Technical Information Bulletin

01-071

T680/T880 Chassis with ISX-15 Evaporator Core Crack

11/21/2019

Line routing diagram

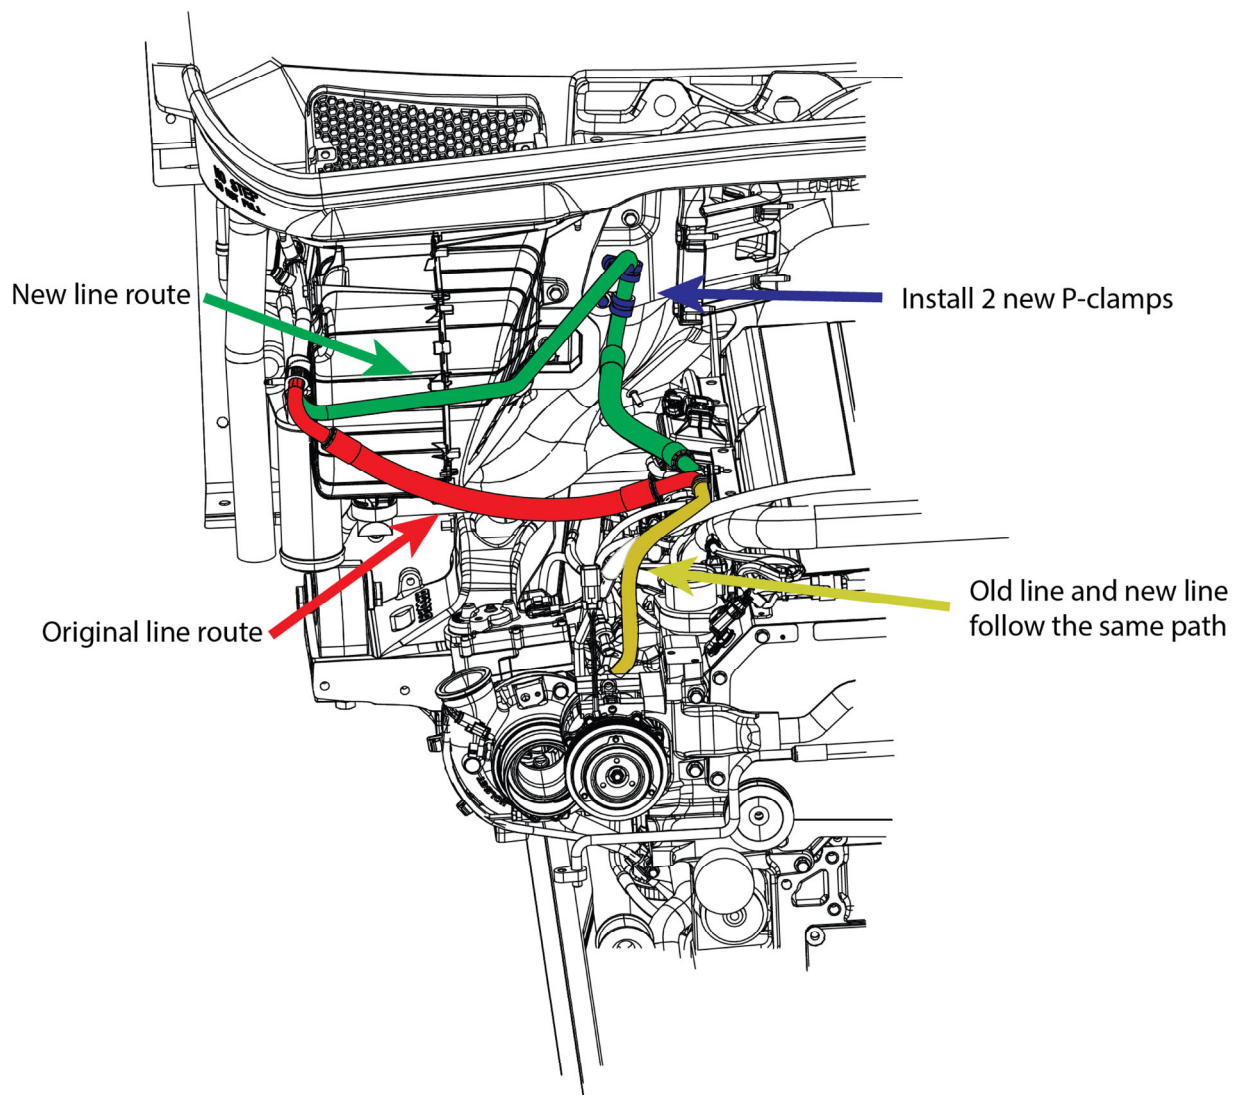
If a customer comes into your dealership and demonstrates the condition above, install the updated suction line(s) in addition to replacing the evaporator core. See the procedure below for updated routing of the updated suction line.

- Remove refrigerant from the system and check for leaks.
 - If leaks are coming from components other than the evaporator core and/or lines included in this bulletin, and the vehicle is no longer covered on warranty, repair/replacement of those components is not covered by this bulletin.
- Install the appropriate new lines for the chassis.
 - The intermediate line located between the suction line and the evaporator core MUST be replaced if the old style (F50-1780) intermediate line is present.
 - The updated suction line (F50-2188) is secured to the plenum with two p-clamps and the existing bolts. Refer to the routing diagram below for updated routing.
- Recharge the system and confirm correct functionality.
